**Subject:** RE: Grenfell - overcladding VE?

**Cc:** Grenfell; BOOTH Philip; Chweechen Lim **Subject:** Grenfell - overcladding VE?

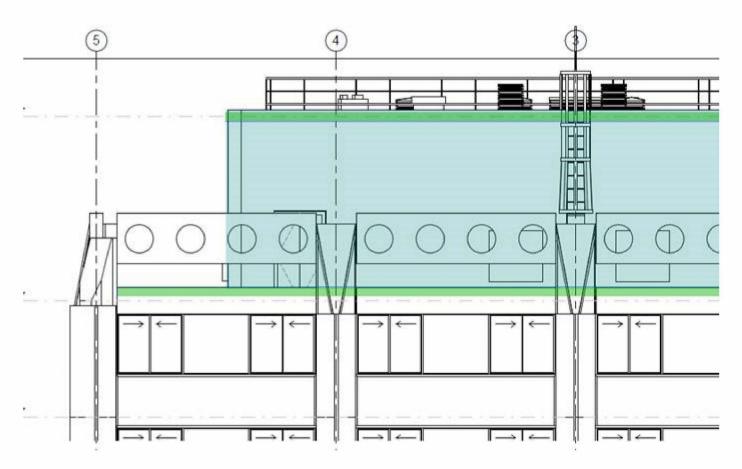
On a much smaller refurbishment project with Max Fordham recently we have successfully argued the case with Building Control for not upgrading areas of roof/wall that are not touched by the refurbishment. As I understand Part L we only need to upgrade the thermal performance of a part which is to be replaced. Eg a roof membrane/window etc.

The existing roof membranes look relatively new (and we think there is some insulation under them) and we have no need to upgrade/re-finish the plant room enclosure. The markup below indicates the area I'm referring to. This would simplify the work and contribute some big savings.

Please could you comment?

- Upgrading of existing roof and tank room areas: Chweechen, perhaps we can make this work all provisional so we get prices but keep our options open. I do not know if the mast climbers need to be attached to the roof and this may cause damage, but in which case we get the areas 'condition surveyed' beforehand. But I agree; this is a good area of potential saving.
- Fire strategy and building control: Bruce can you make this easy for me, and give me direct tel nos and any references etc. Also you need to do me a bullet point prompt on the specific areas so I mention all the issues. (3 days of holiday .....)
